Liverpool Range Wind Farm – Modification 1

Thank you for your referral through the Major Projects Portal dated 13 September 2022 to the Biodiversity, Conservation and Science Directorate (BCS) and National Parks and Wildlife Service (NPWS) of the Department of Planning and Environment (DPE) inviting comments on the Modification Application for the Liverpool Range Wind Farm.

Attachment B – BCS detailed biodiversity comments and recommendations

Figure 1: Native vegetation cover in Kerrabee IBRA sub-region

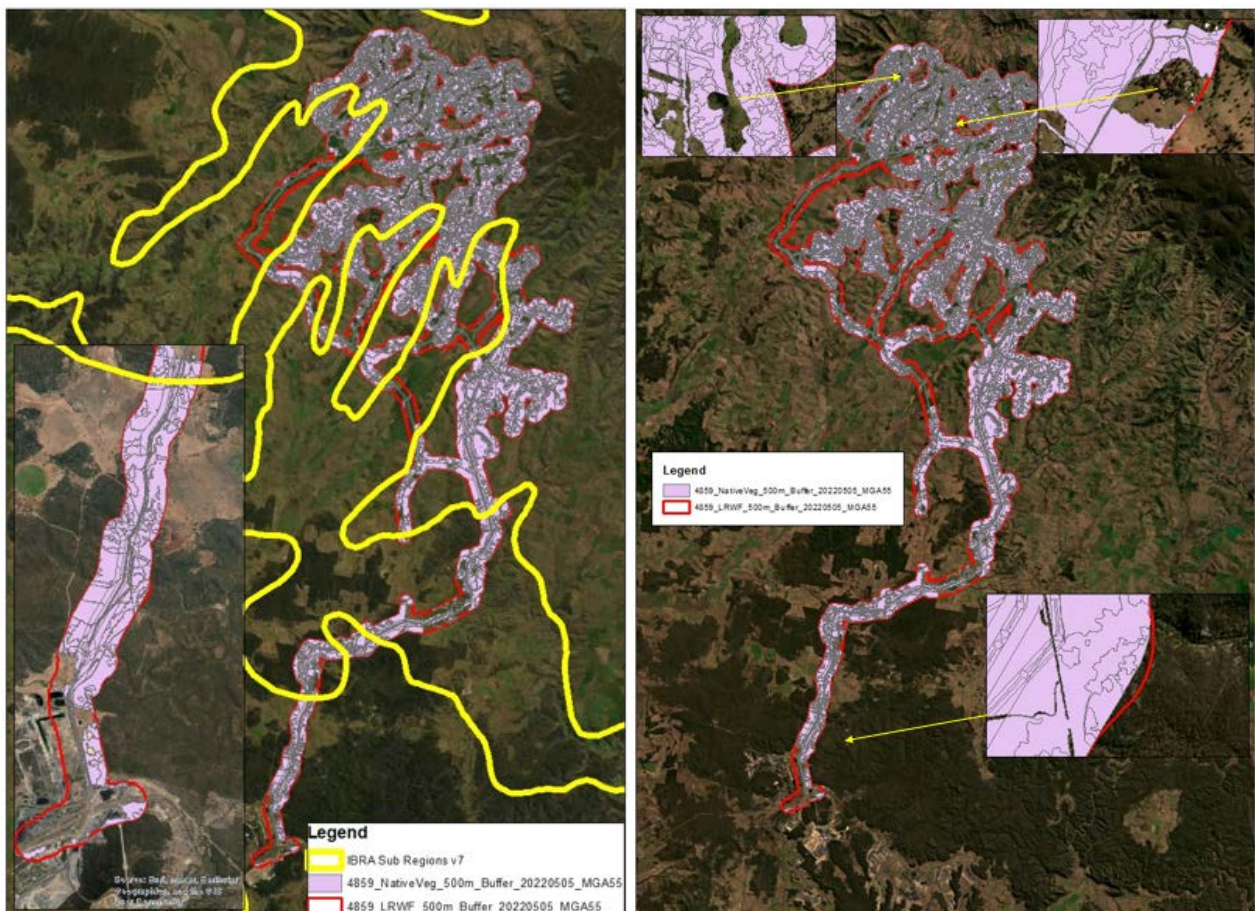
BCS does not consider the native vegetation cover proposed in the BDAR and BAM-C to be representative of individual assessments for each subregion. For example, within the Kerrabee IBRA sub-region, approximately 2,000 hectares is included within the LRWF native vegetation buffer, of which 1,837 hectares is native vegetation (See Figure 1). Therefore, the native vegetation cover for the Kerrabee IBRA sub-region BAM-C should be approximately 91% rather than 4%.

BCS notes that the native vegetation cover within the 500m buffer has been coarsely mapped across the project site. In Figure 1 above, BCS has provided examples of native vegetation which has not been included within the vegetation cover class assessment. It should be noted that native vegetation extent identified and mapped within the subject site (Inclusive of both woody and non-woody native vegetation) is required to be included within the native vegetation cover polygon on the landscape assessment map and the vegetation % cover class assessment (Section 3.2 of the BAM 2020).

Finer scale vegetation extent mapping, including both woody and non-woody vegetation, is required in accordance with the requirements set out within Section 3.2 of the BAM 2020. If areas of native vegetation extent are changed within the BDAR, this must also be made consistent within the BAM-C. As vegetation cover estimates function as a habitat suitability filter for candidate threatened species this may also impact the species list generated for the project.

- 2.1 Recalculate the percentage of native vegetation cover for each IBRA sub-region intersected by the project.
- 2.2 Review the list of candidate species in each IBRA subregion to determine whether any additional threatened species require assessment.
- 2.4 Biodiversity credits be recalculated for each IBRA subregion.

- 3.1. Undertake finer scale vegetation extent mapping and include both woody and non-woody vegetation within mapping

Figure 2. Example of woody vegetation mapped as Category 1 Land ¹

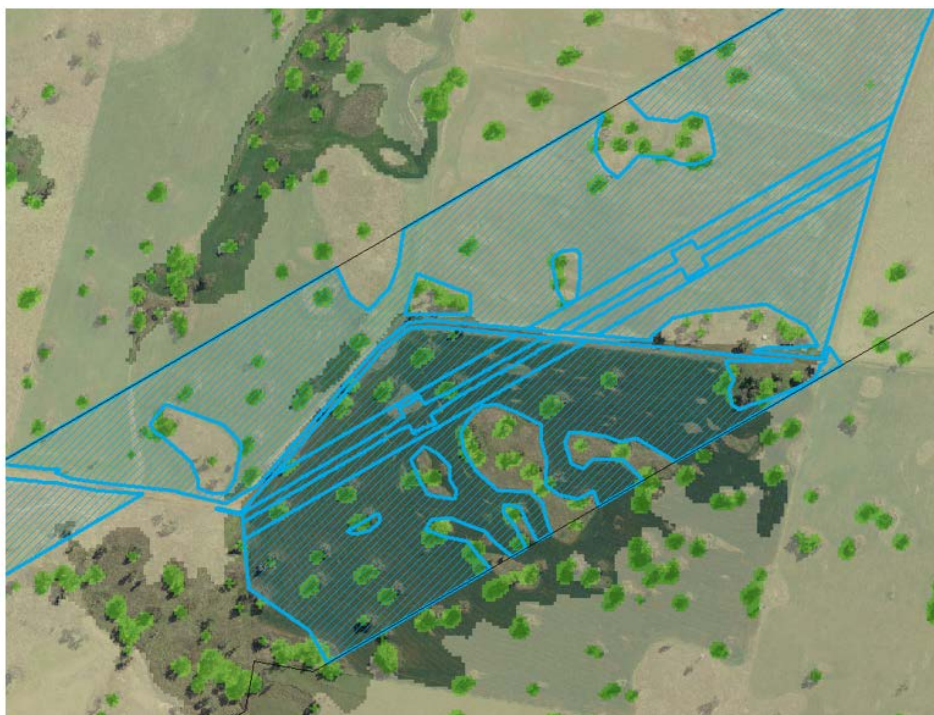
In addition to the above, the approach taken to categorising woody vegetation seems to have resulted in a significant amount of vegetation (mapped on the NSW native vegetation extent layer) being classified as Category 1, when they should be Category 2. In Figure 2 below, BCS has provided examples of native vegetation which has been classified as Category 1.

- 6.1 Provide further justification for Category 1 land use and clearly define all land use in the subject land clearly in spatial data and the BDAR

Figure 3. Example of woody vegetation mapped as Category 1 Land

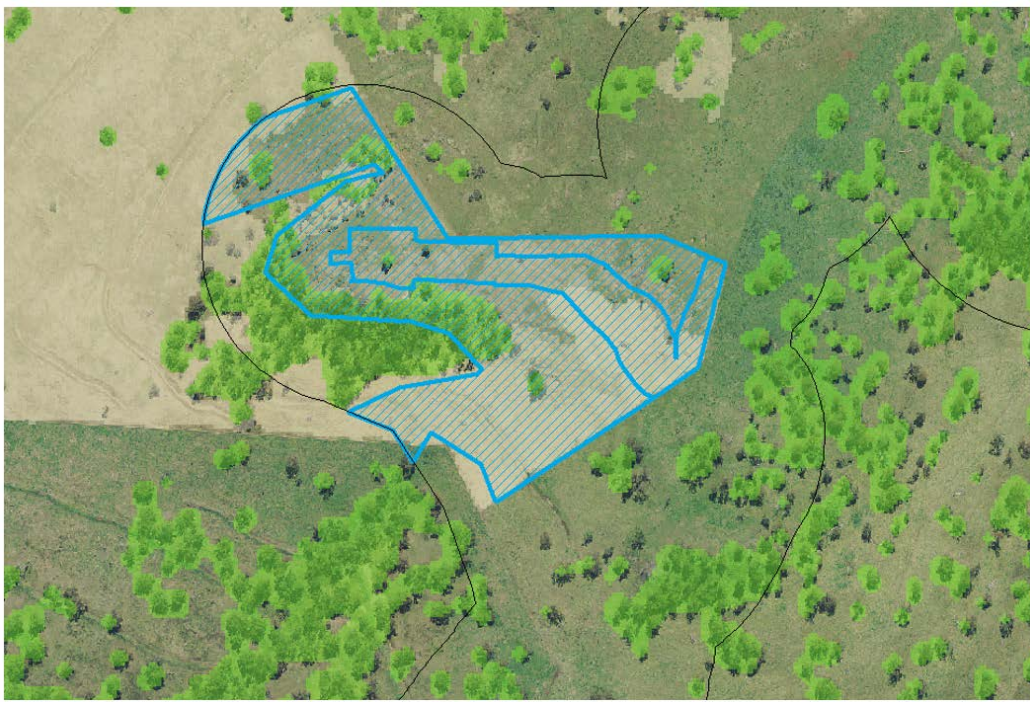
Furthermore, PCT 484, which is associated with TEC's, is present throughout the unsurveyed area and intersects with the Modified Development Corridor (Figure 3) but is not mentioned in the BDAR. A TEC equivalency assessment for all PCTs identified within the BAM-C as potentially equivalent to a BC Act or EPBC Act listed TEC, should be conducted. TEC equivalency assessments require detailed and systematic comparison of a vegetation patch's compositional, structural and functional attributes against the diagnostic criteria held in both NSW listings and Commonwealth conservation advice.

Figure 4. Potential EPBC representative Box Gum Woodland (pink zones) intersecting with the proposed development corridor

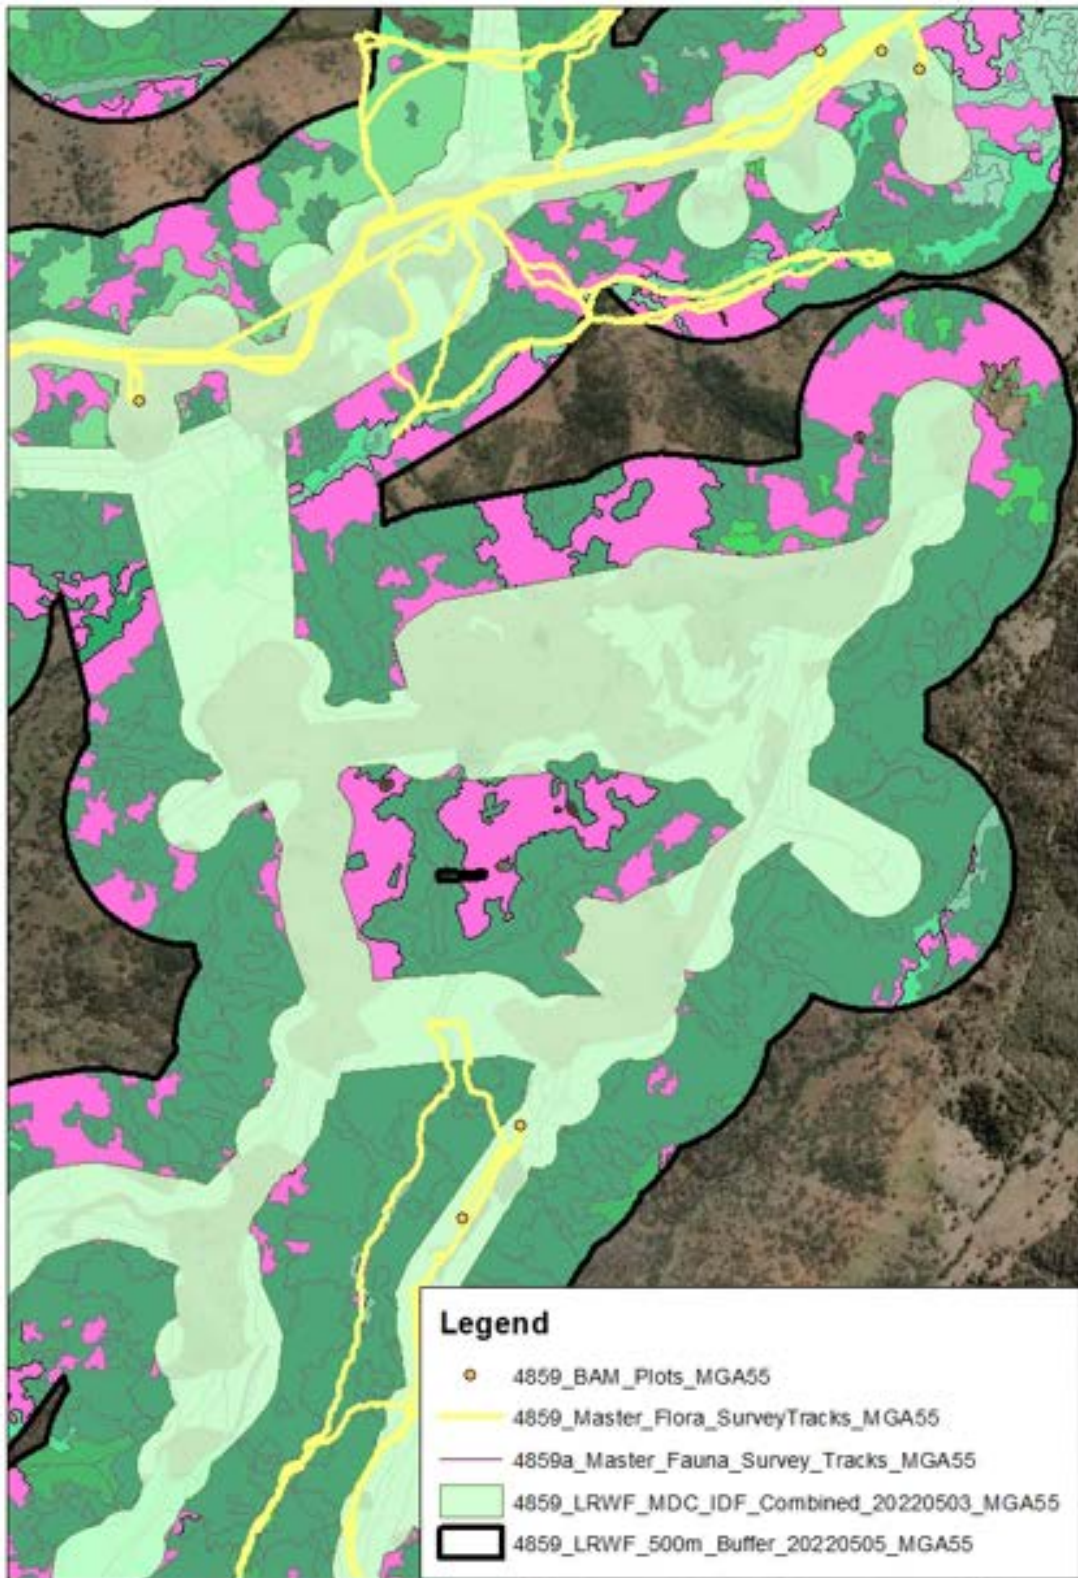
BSC has noted that the BDAR includes quantifiable metrics for assessing TEC equivalency in plot surveys. However, when reviewing spatial data, BSC notes that there is approximately 1,500ha of potential EPBC Act Box Gum Woodland which contains no vegetation plots, rapid assessments, or meandering surveys. This area has been determined to be non-consistent with the EPBC Act representation of the community. It is unclear to the BCS what evidence has been relied upon to determine the absence of EPBC Act listed Box Gum Woodland from these areas.

If data has not been collected within a given patch of vegetation a precautionary approach should be followed, and the patch should be assumed as equivalent to both BC Act and EPBC Act TEC listings.

- 10.1 Provide evidence that all vegetation has been appropriately surveyed in detail to inform TEC equivalency assessments and support the determination of non-equivalence to EPBC Act listed TECs.
- 10.2 If evidence has not been collected, assume the presence of the EPBC Act listed TEC.

Figure 5. Area of proposed development which requires further survey effort

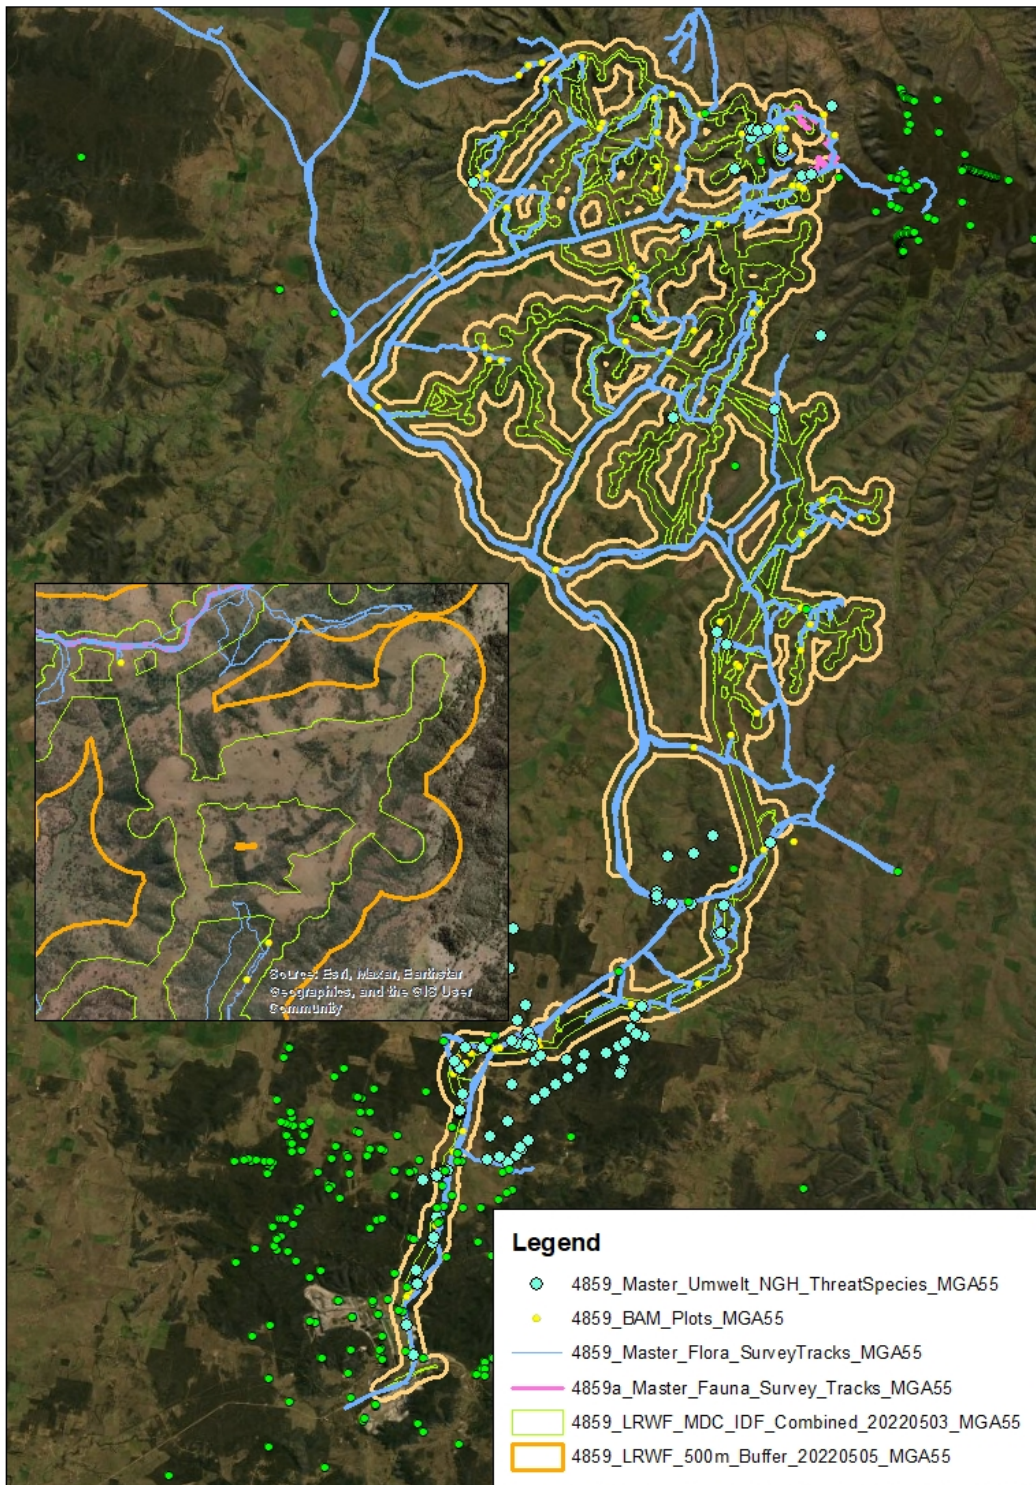
BSC has noted that no fauna or flora surveys were conducted in one section of the Modified Development Corridor which is within 2km of Coolah Tops National Park (see Figure 4).

It appears that threatened species survey has not been adequately undertaken in this area, and therefore further survey effort will be required to justify the exclusion of potential habitat for candidate species. For example, on the western edge of Coolah Tops NP adjacent to the proposed site, there are multiple records for the Barking Owl, Powerful Owl, Little Eagle and a record of a Black Falcon. The unsurveyed area is comprised of a mosaic of woodland and agricultural land along ridges which provide ideal breeding habitat and foraging opportunities for these candidate species. BSC considers these species to be at particular risk of turbine collisions. BSC also notes that these species should be mapped in Figure 3.5 of the BDAR.

- 12.1 Provide further justification for the exclusion of candidate species in accordance with the BAM.
- 12.2 Conduct surveys for threatened flora and fauna in woodland patches in the modified development corridor adjacent to Coolah Tops National Park
- 12.3 Revise threatened species mapping in the BDAR
